**ADDENDUM NO. 1**

November 17, 2017

For the  
**STAGECOACH INN RELOCATION**  
Round Rock, Texas

by  
**ARCHITEXAS**

# RELOCATION SITE PLAN

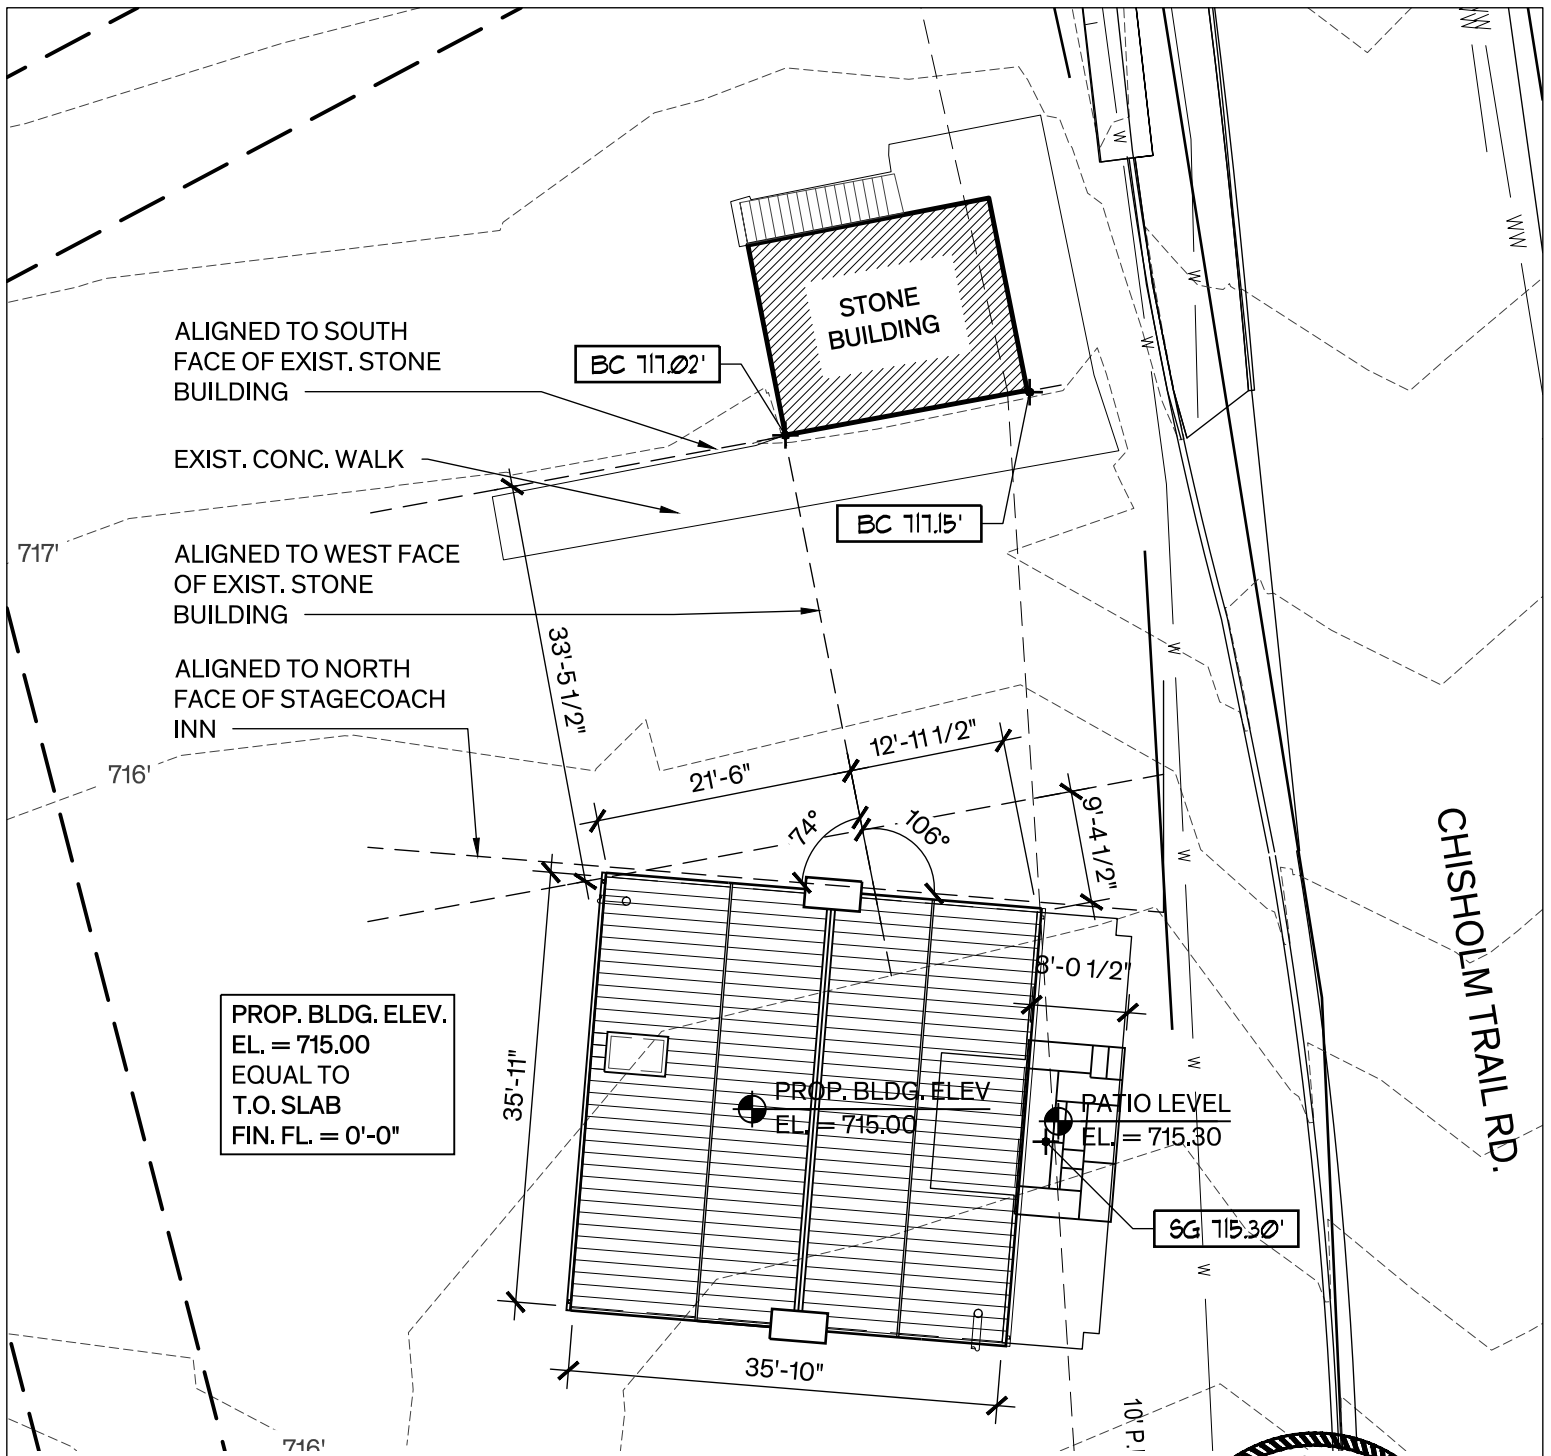
1. A French drain is to be added along the north and west perimeter of the building and terminated to the south. Add location of French drain to Detail No. 1. See attached drawing, 1 page (8.5"x11")
2. Additionally, the attached detail removes the control dimension from the northwest corner of the Stagecoach Inn to the south west corner of the existing walkway.

# Dimension Control Plan

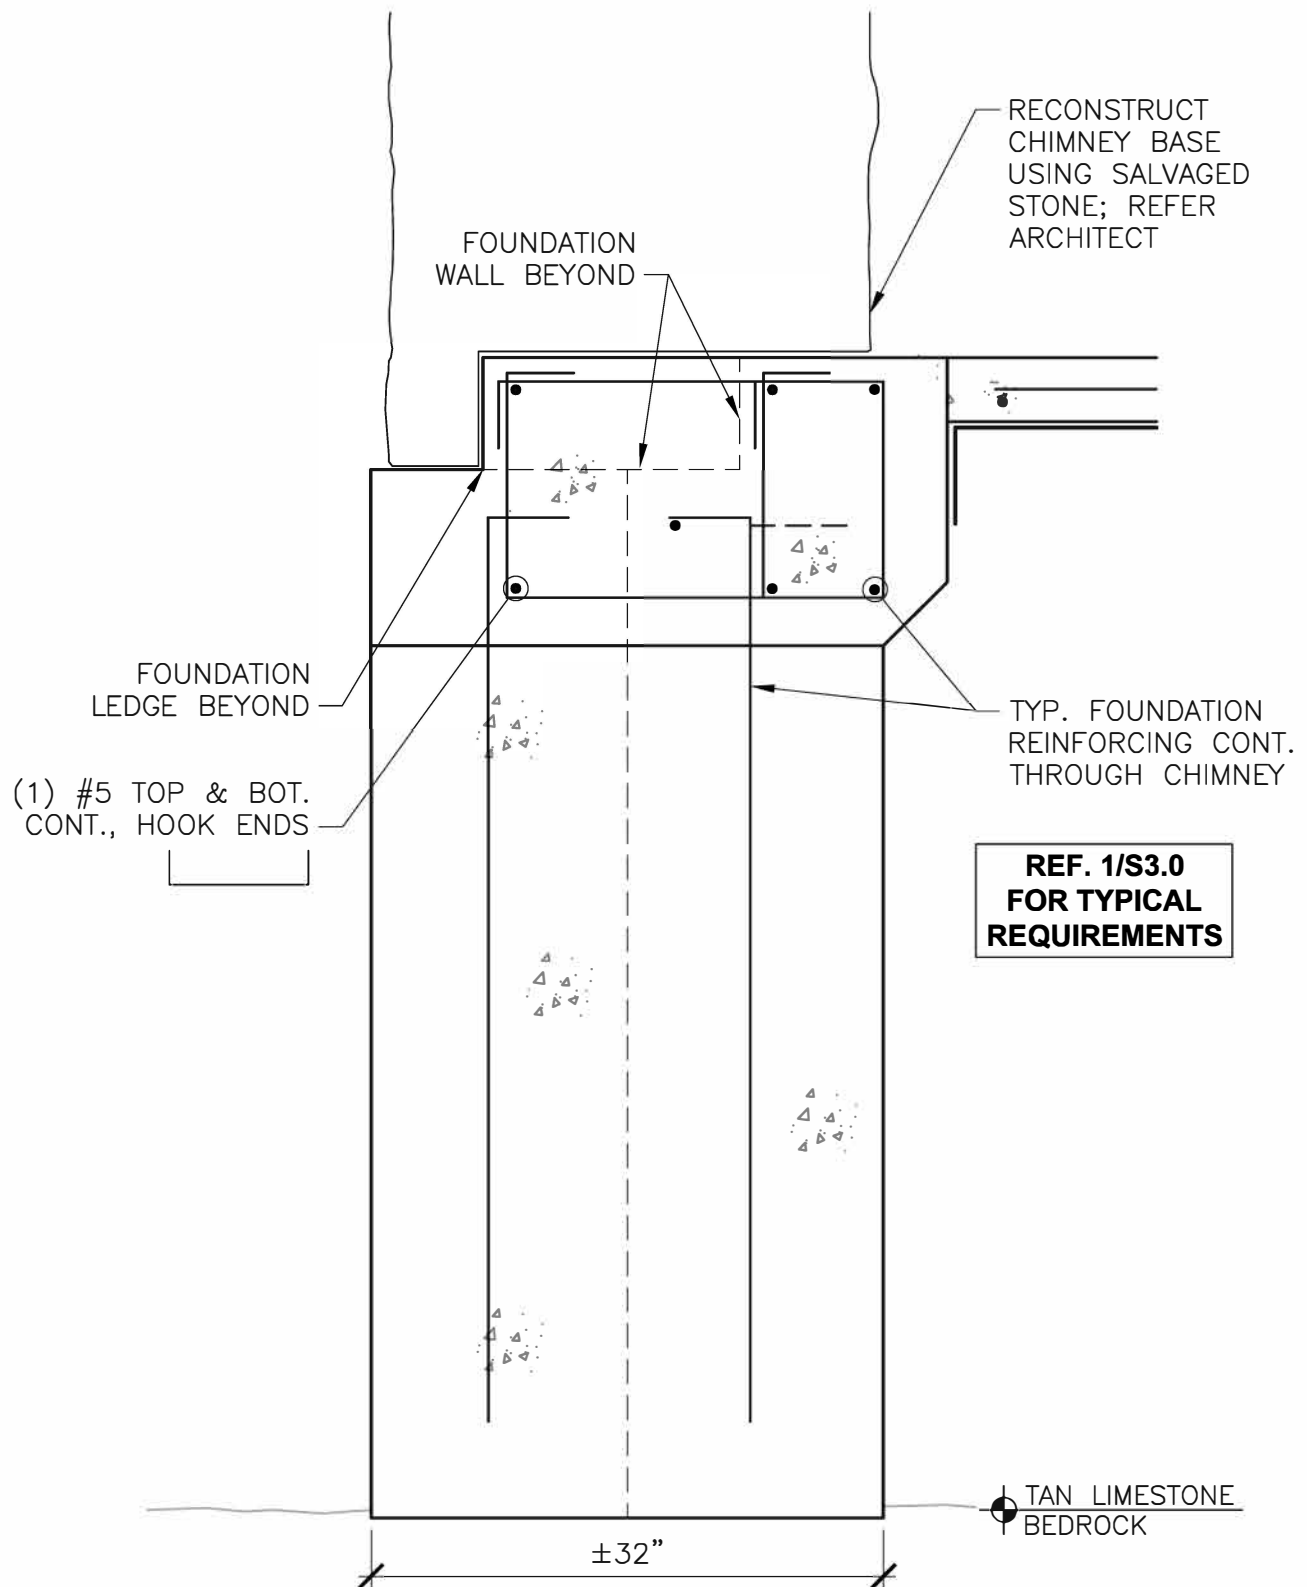
Add the attached detail No.2 "Dimension Control Plan" to Sheet A1.01.

DETAIL NO. 4 CHIMNEY FOUNDATION SECTION, TYP.  
See Attached drawing, 1 page (8.5"x11")
